PROPOSED CHANGE, EAST BRIDGE, LEVEL 02

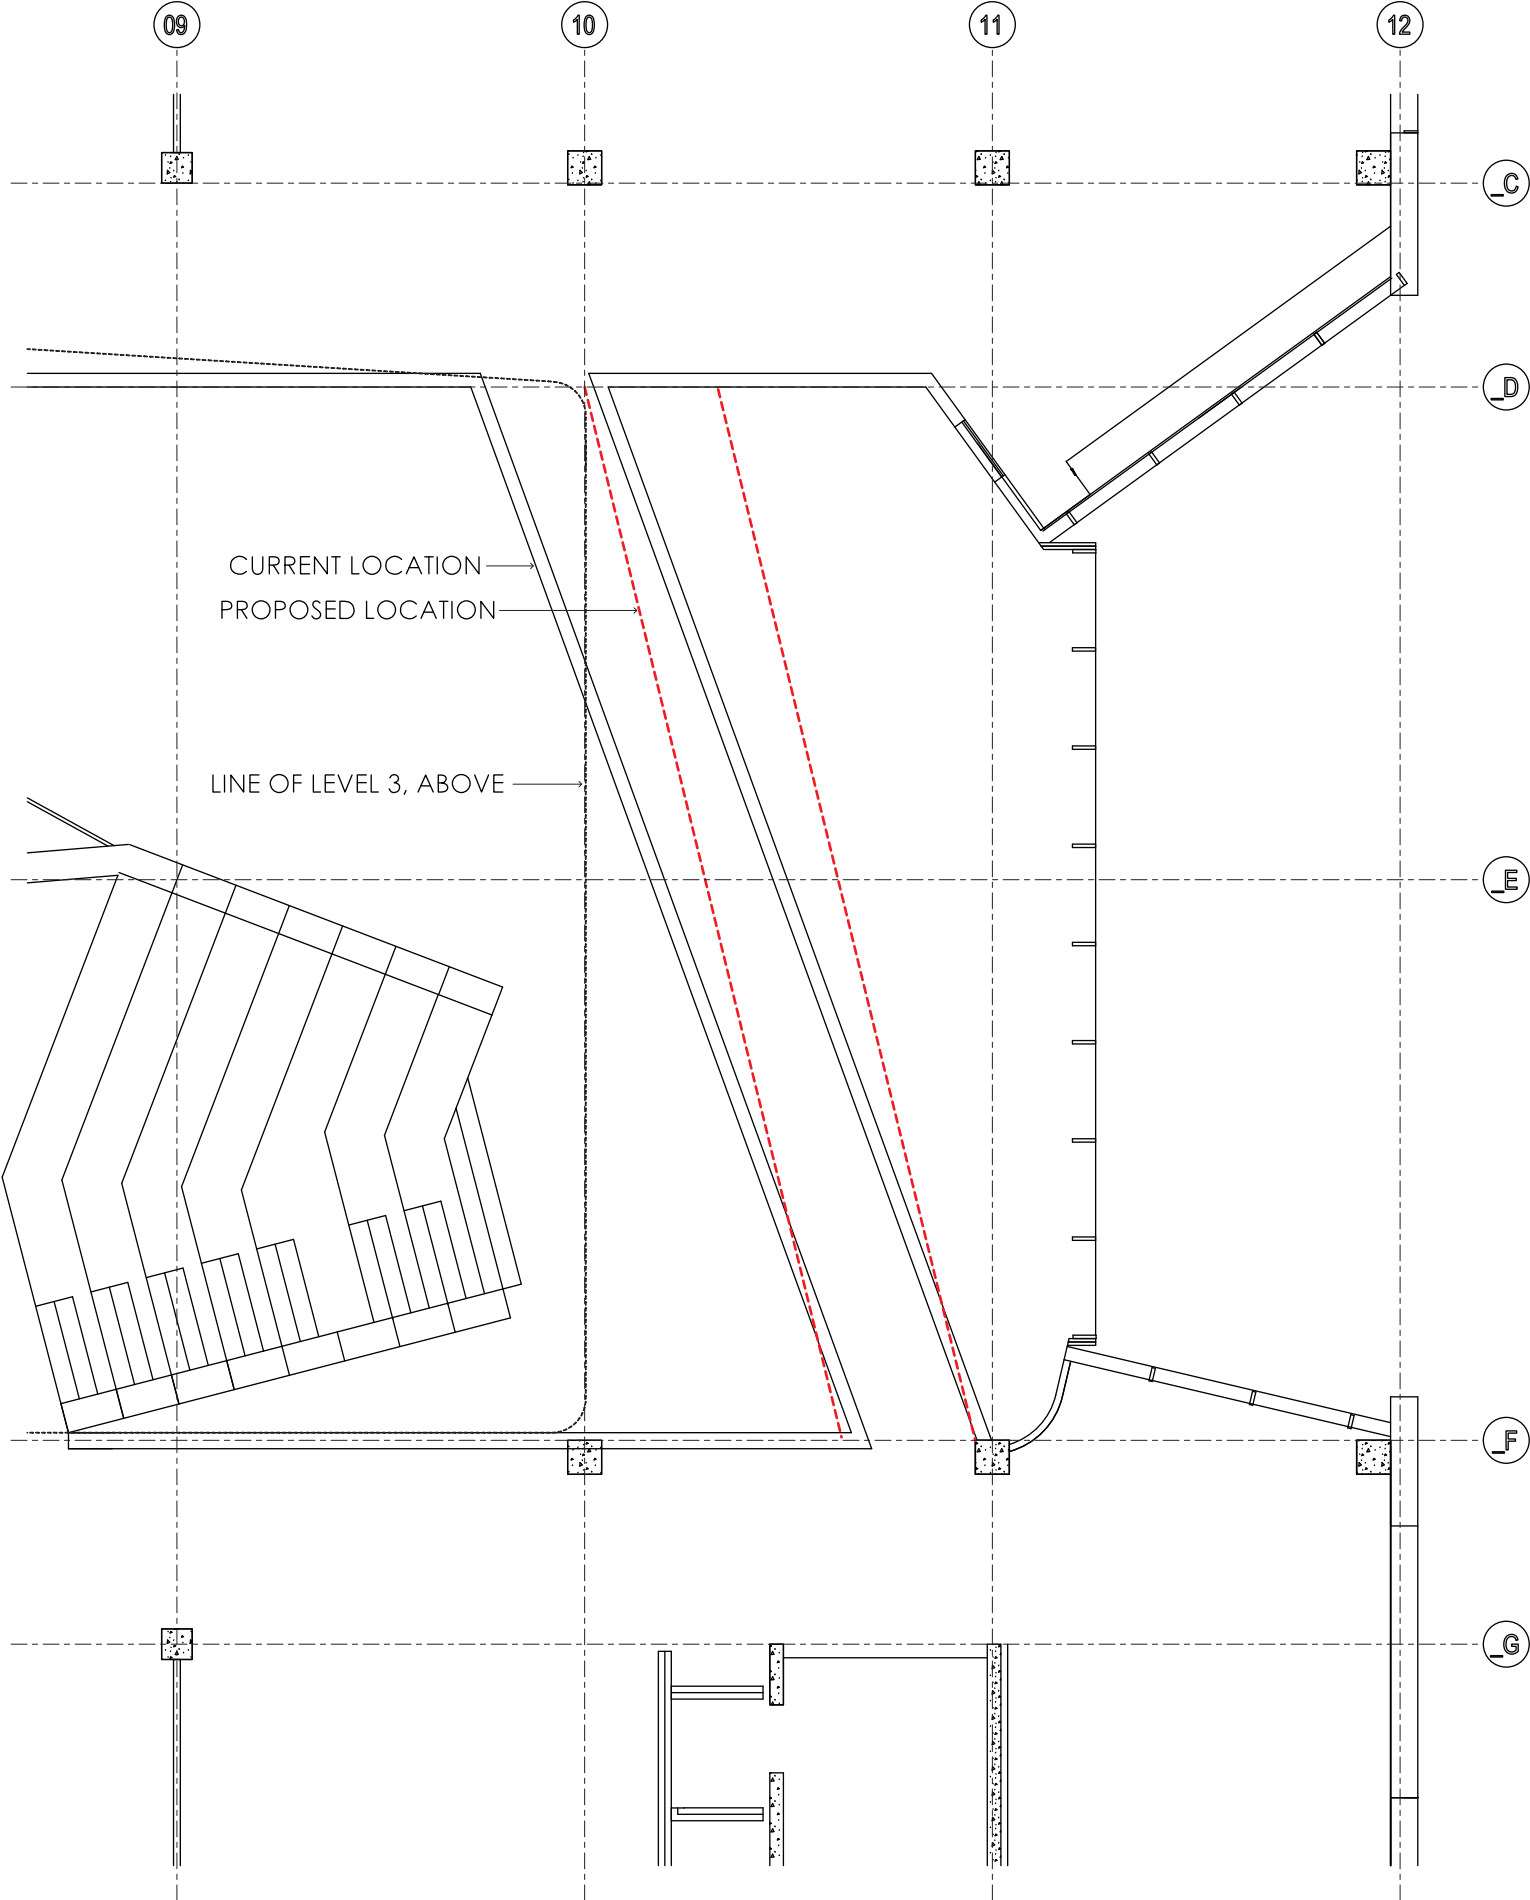
STRUCTURE PER CURRENT MODEL. 100 x 100, IRREGULARLY SPACED

DESIRED REVISION: REGULARLY SPACED STRUCTURE
WITH ALTERNATIVE PROFILE, RUNNING OUTBOARD
OF BRIDGE

WEST BRIDGE, ALTERNATIVE STRUCTURAL PROFILES

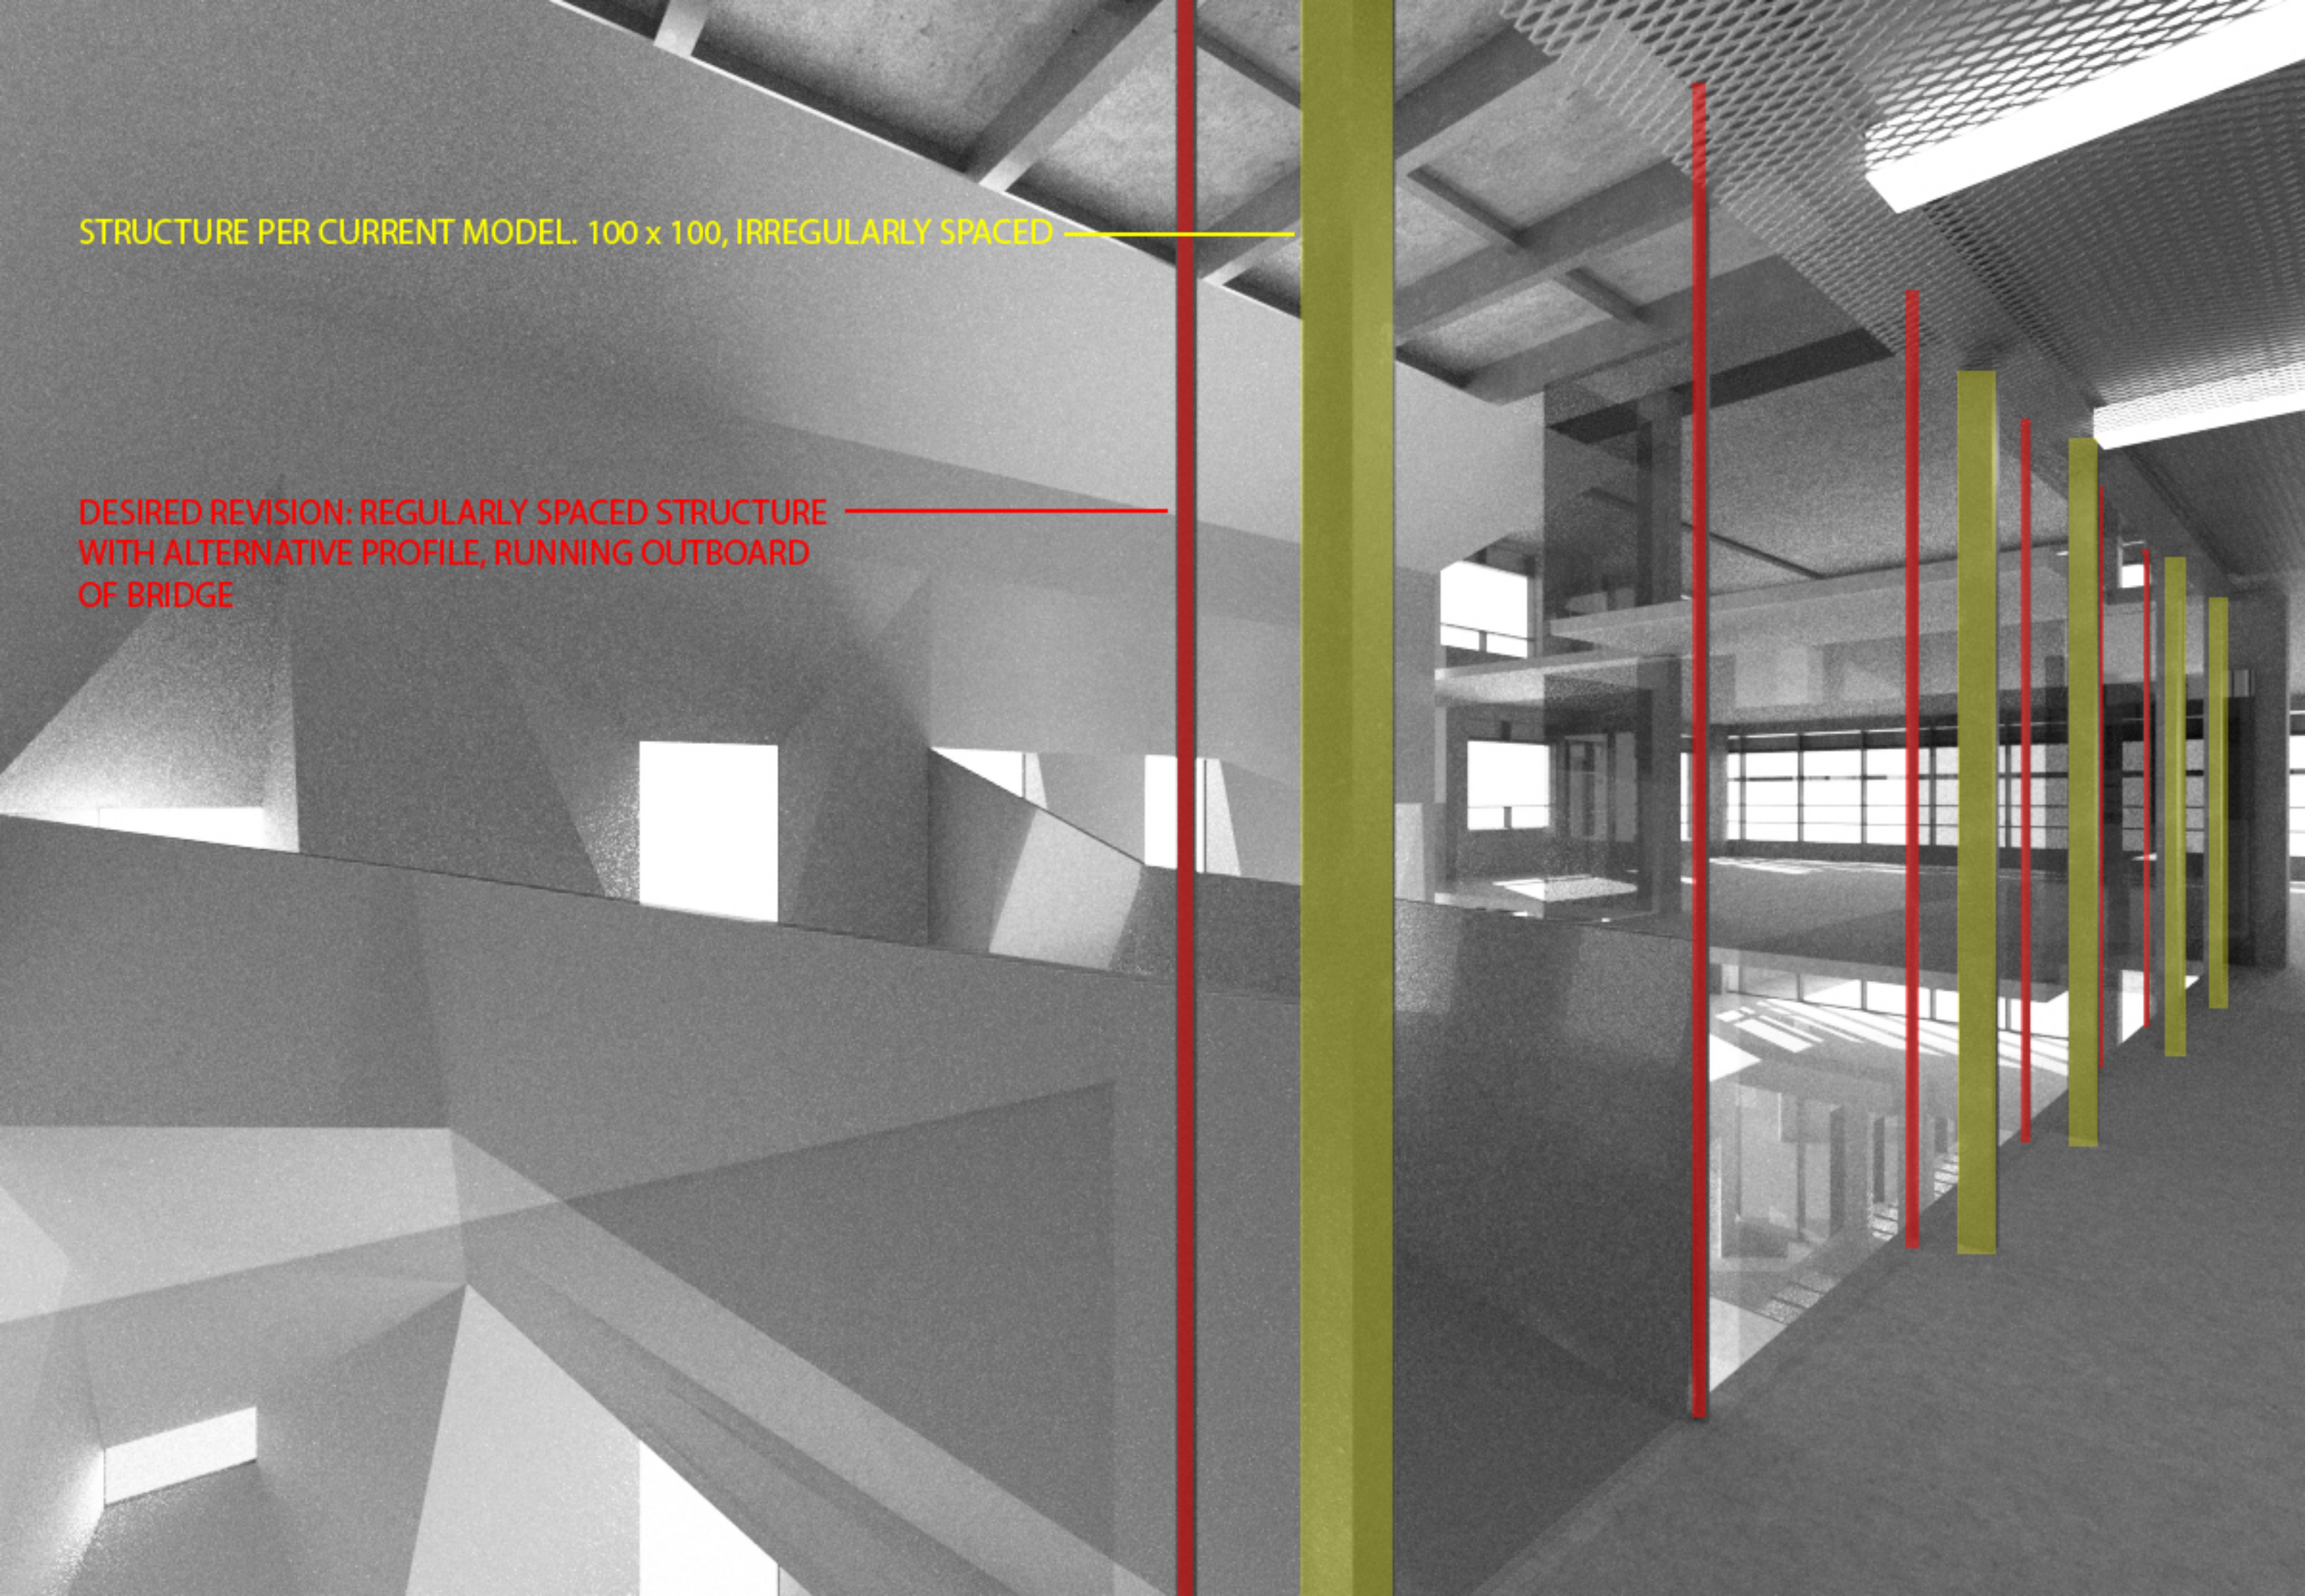
CURRENT CONDITION, 100mm x 100mm

ALT. OPTION _A

STEEL PLATE, 25mm x XXXmm

ALT. OPTION _B

STEEL PLATE, 25mm x XXXmm
PLUS 15mm x XXXmm PLATES

ALT. OPTION _C

PAIR OF 40mm RODS
